ATTACHMENT A
NIAGARA MOHAWK POWER CORPORATION
LICENSE NO. DPR-63

Proposed Changes to Technical Specifications (Appendix A)

Replace the existing pages 4c, 20, 63, 64a, 64b, 64c, 65, 66, 67, 68, 69, 69a, 69a1, 69b, 70, 70a, 70b, 70d, 265 and 265a. These pages have been retyped in their entirety with marginal marking to indicate the changes to the text. Add new page 265a.

NIAGARA MOHAWK POWER CORPORATION
 NINE MILE POINT UNIT 1
 CORE OPERATING LIMITS
 REPORT

Figure A
NMP-1 MAPLHGR Limits (GE 8DNB277)

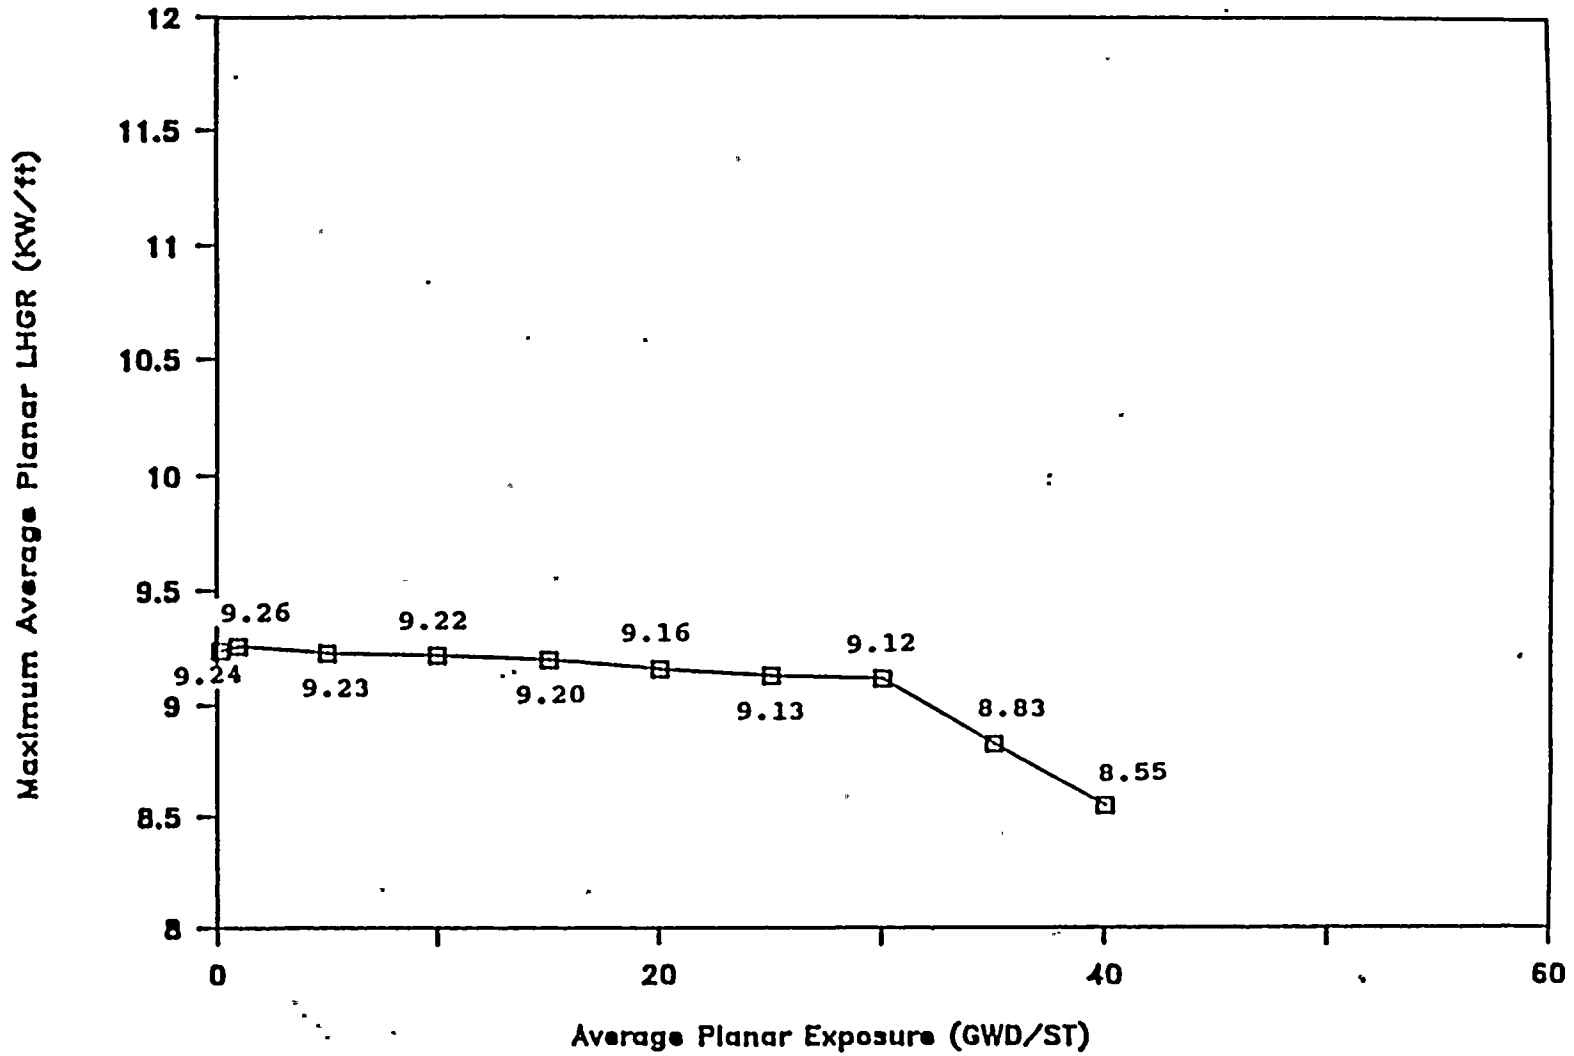
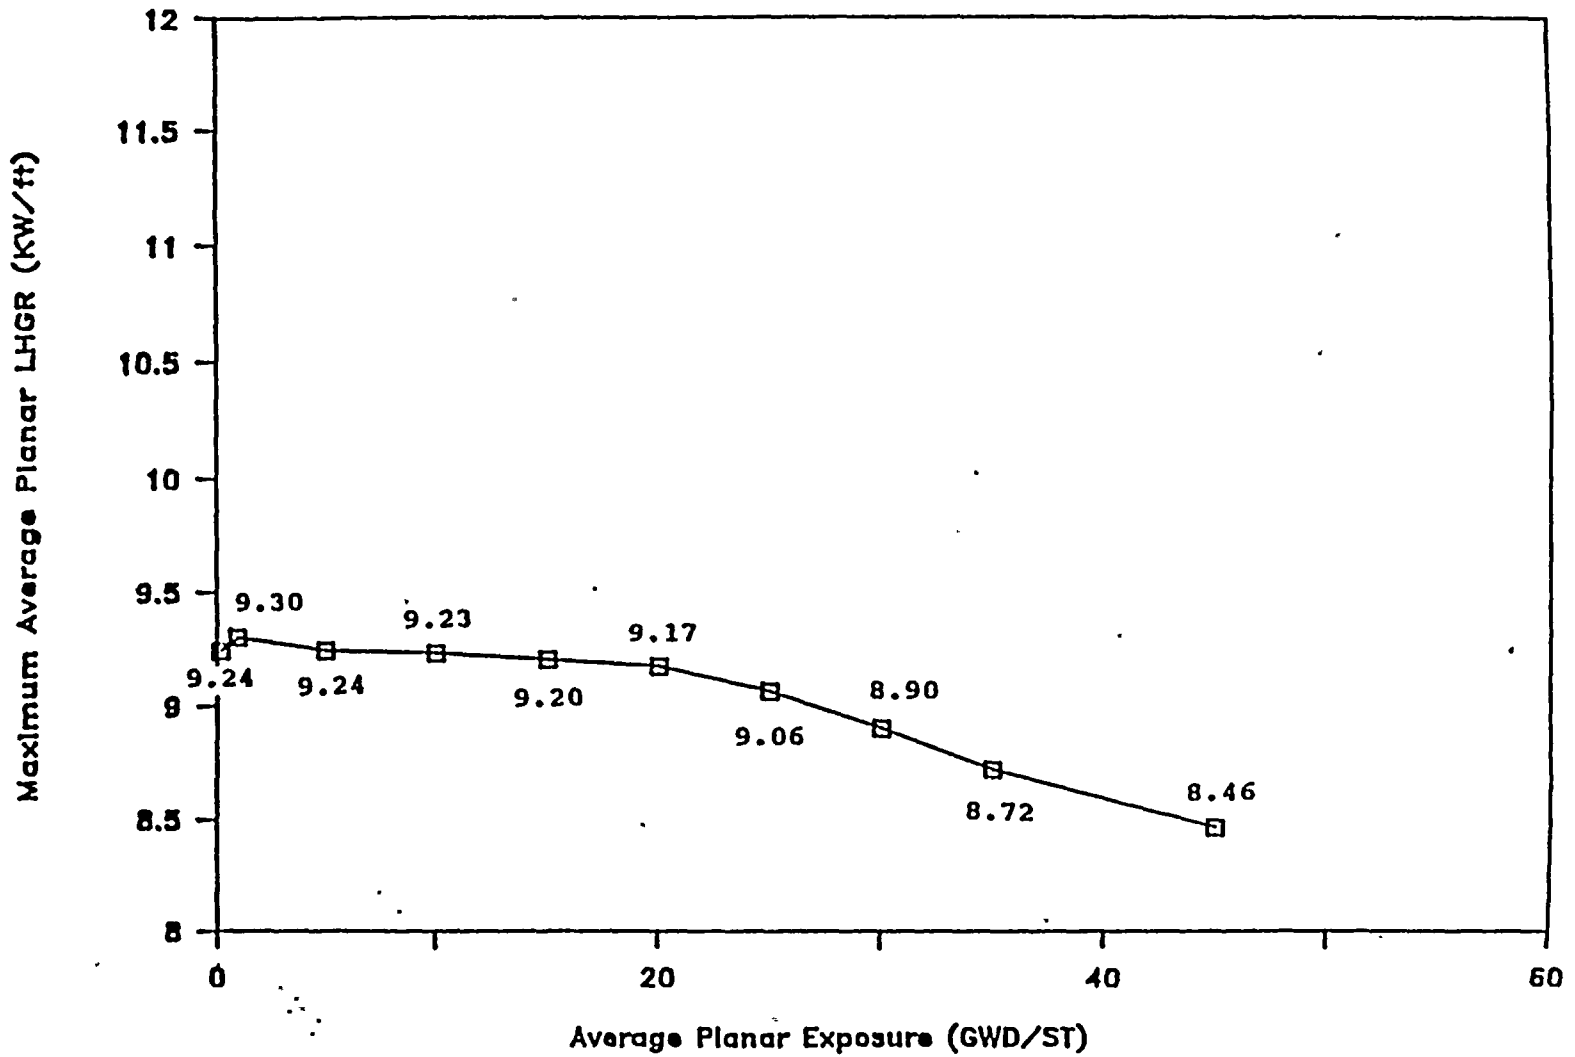
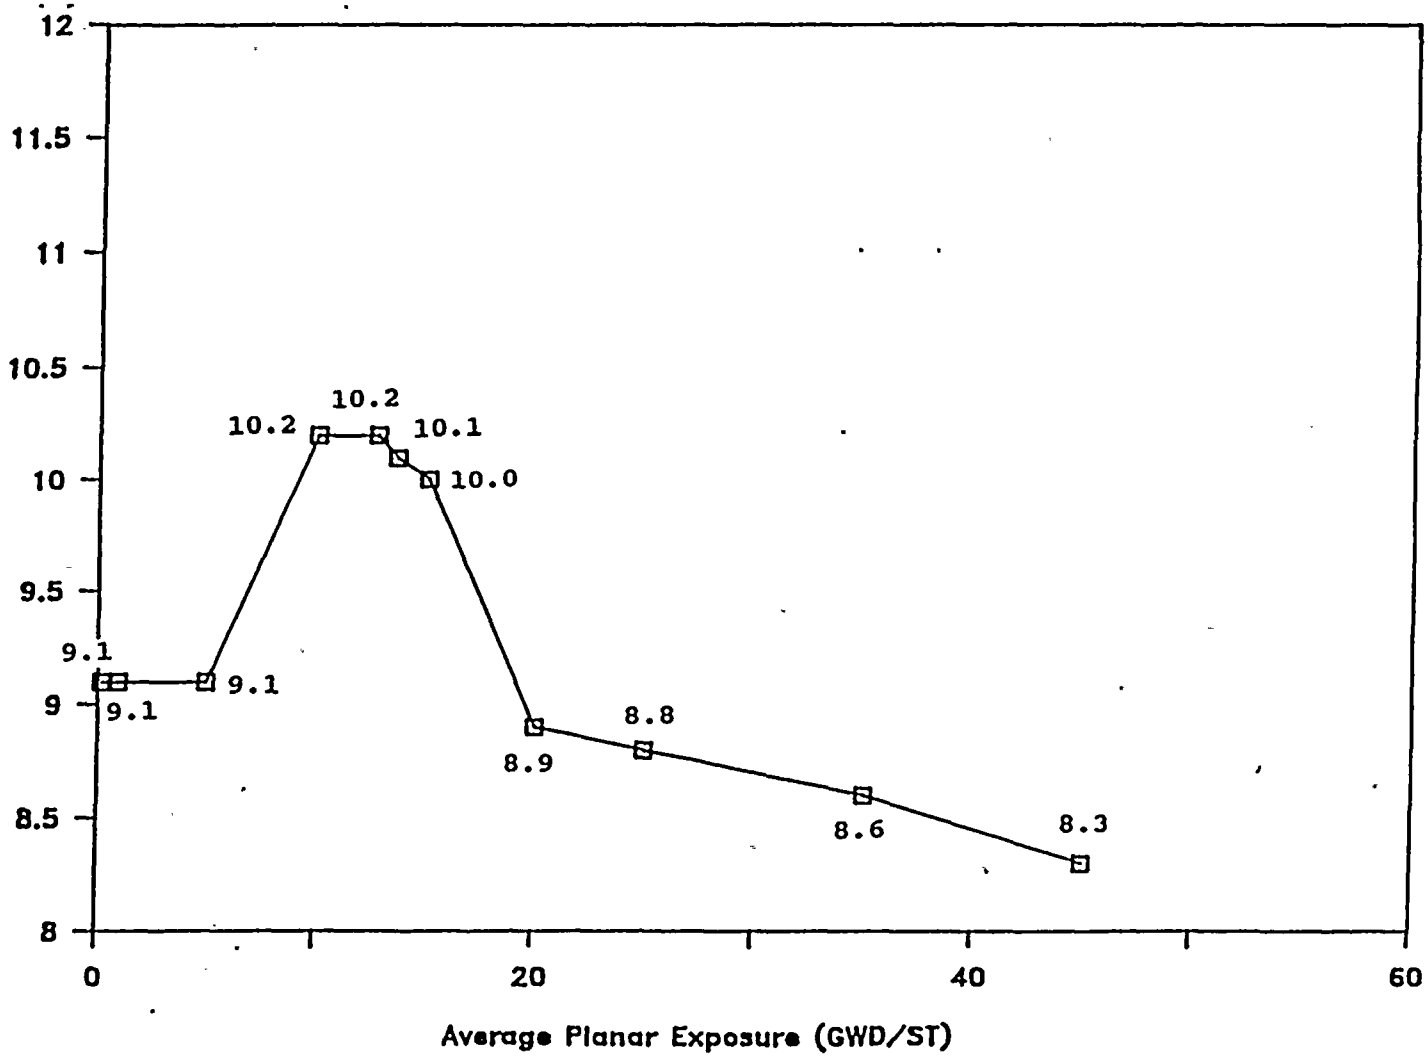
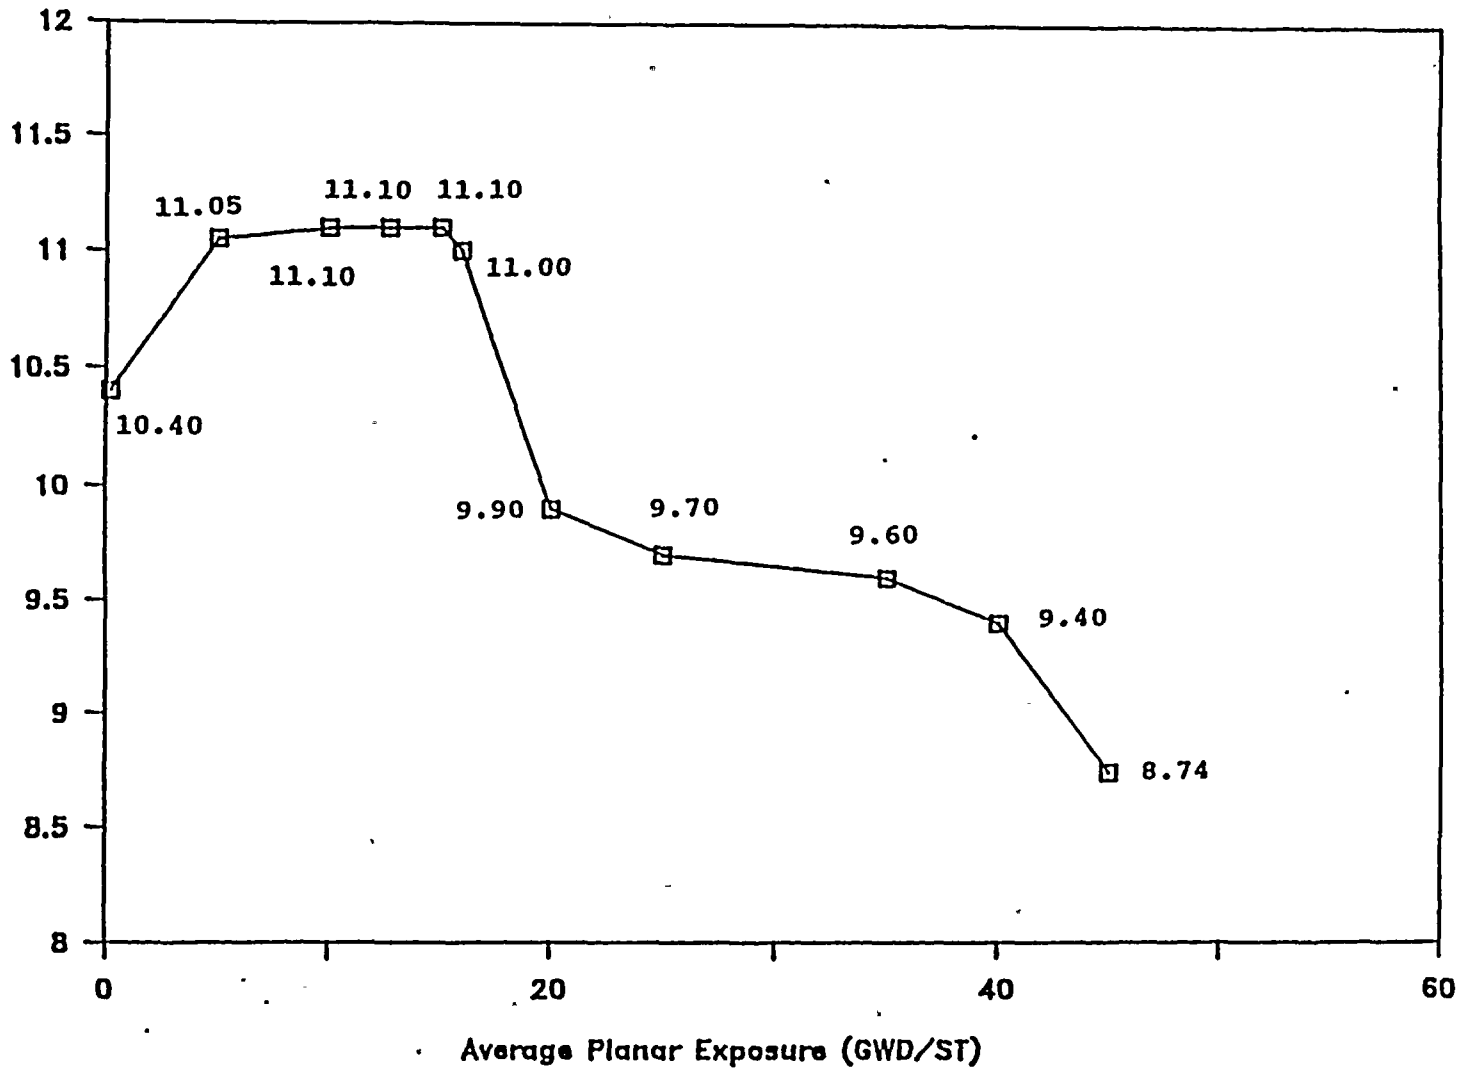
During power operation, the APLHGR for each type of fuel as a function of average planar exposure shall not exceed the limiting value shown in Figures a, b, c and d.

During partial loop operation with four recirculation loops in operation and the remaining loop isolated or unisolated, the APLHGR as a function of average planar exposure shall not exceed 98 percent of the limiting values shown in Figures a and b and shall not exceed 99 percent of the limiting values shown in Figures c and d.

During partial loop operation with three recirculation loops in operation and the two remaining loops isolated or unisolated, the APLHGR as a function of average planar exposure shall not exceed 96 percent of the limiting values shown in Figures a and b and shall not exceed 99 percent of the limiting values shown in Figures c and d.

Figure E K_f Factor

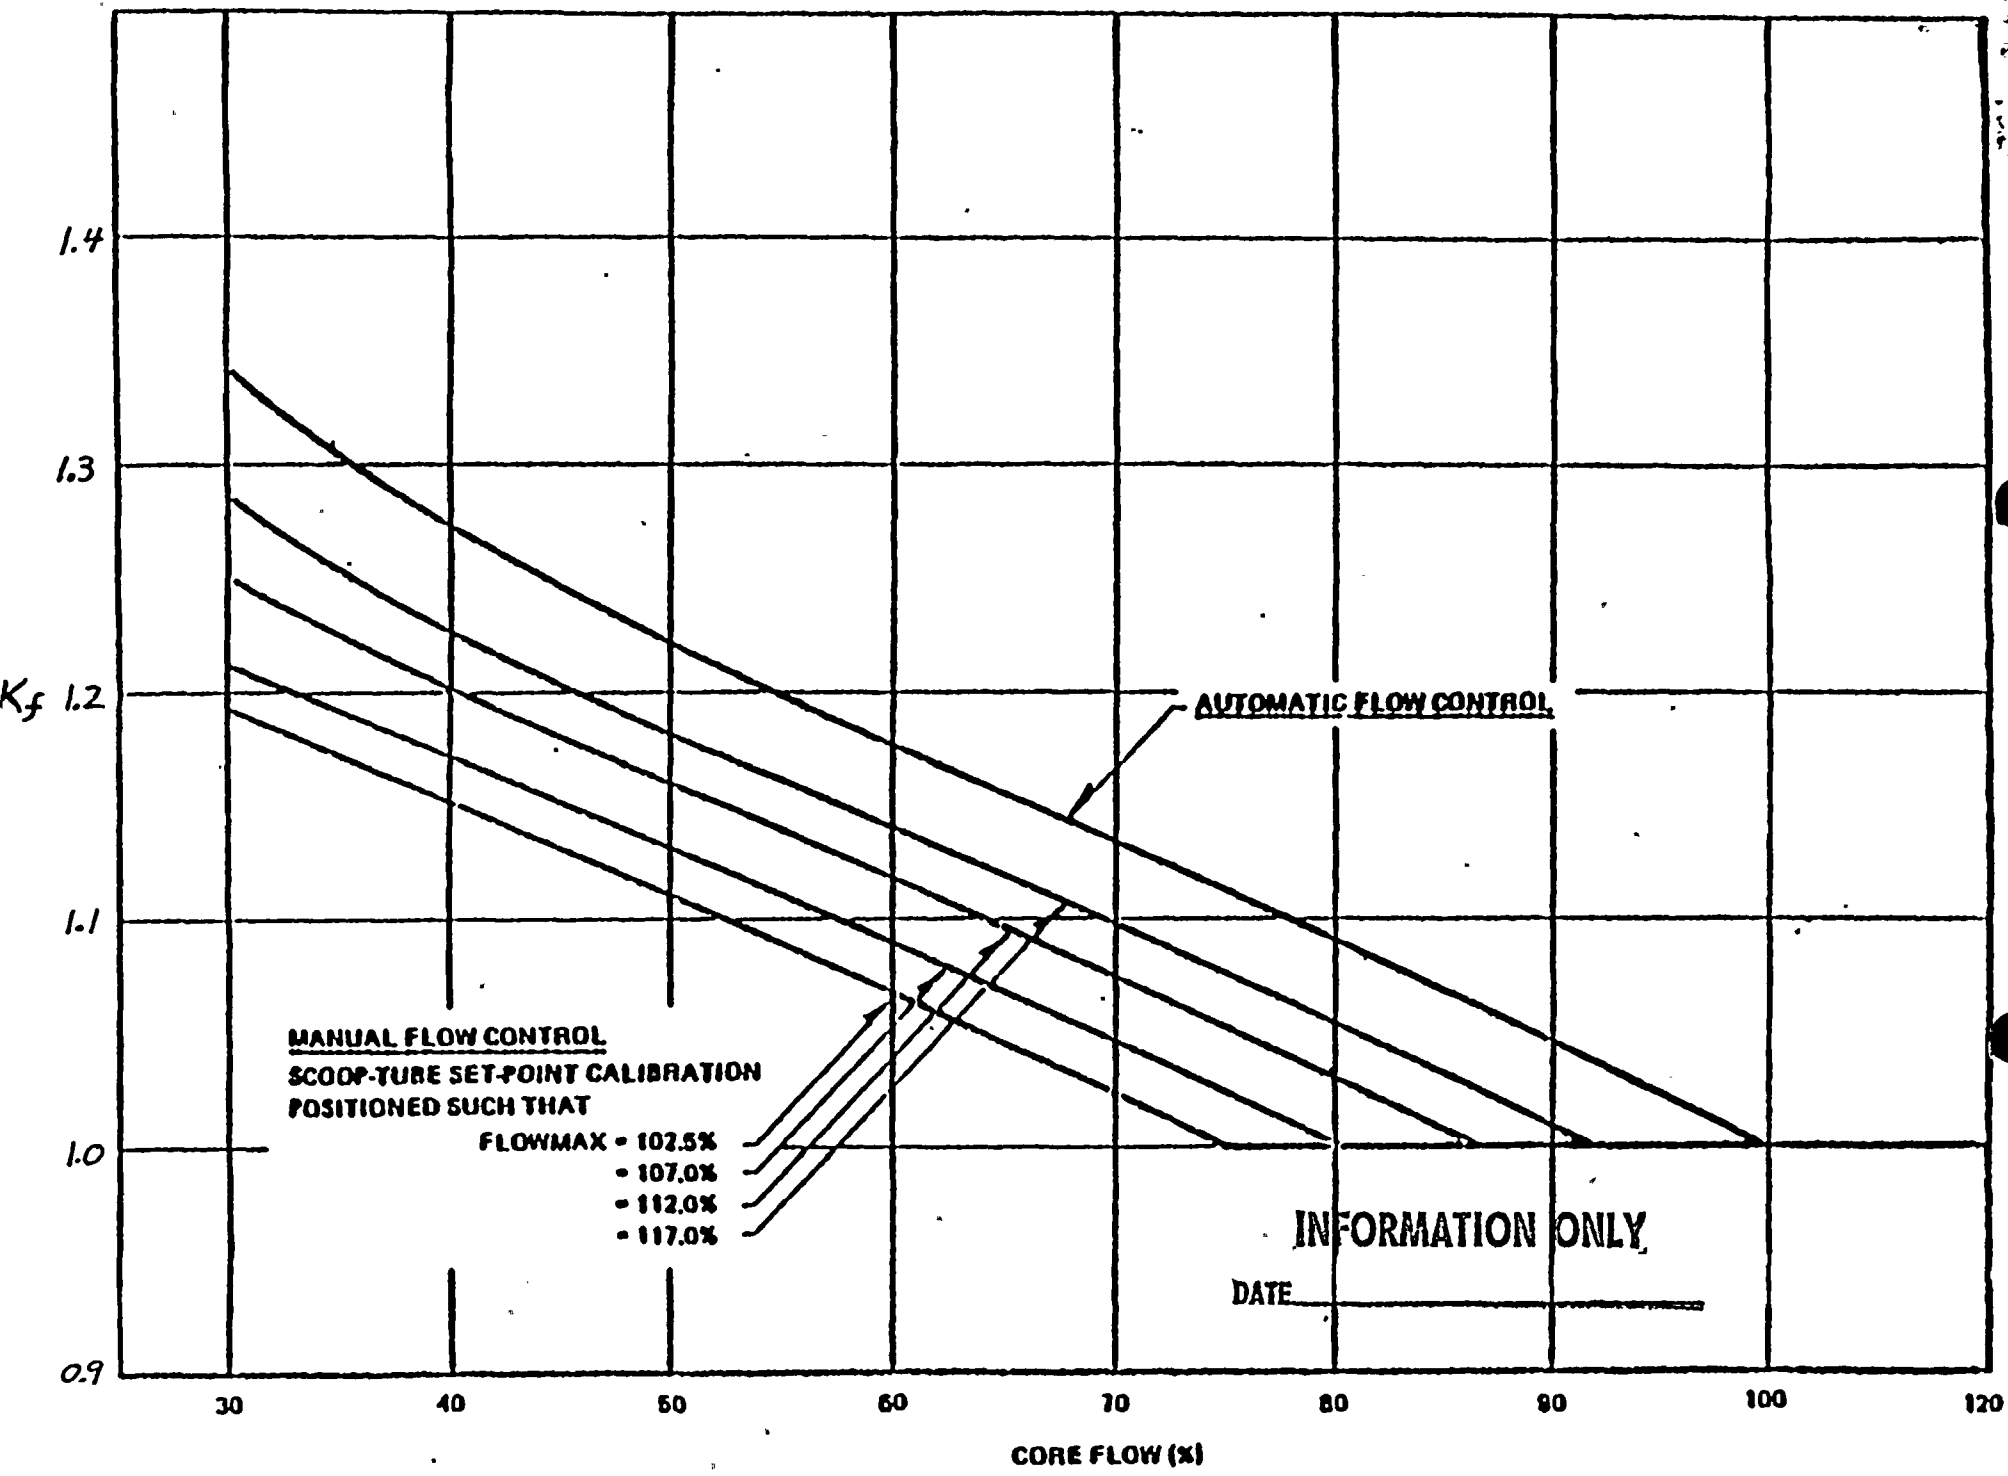
For core flows other than rated the MCPR limit shall be the limit identified in Table 1 times K_f where K_f is as shown in Figure e.
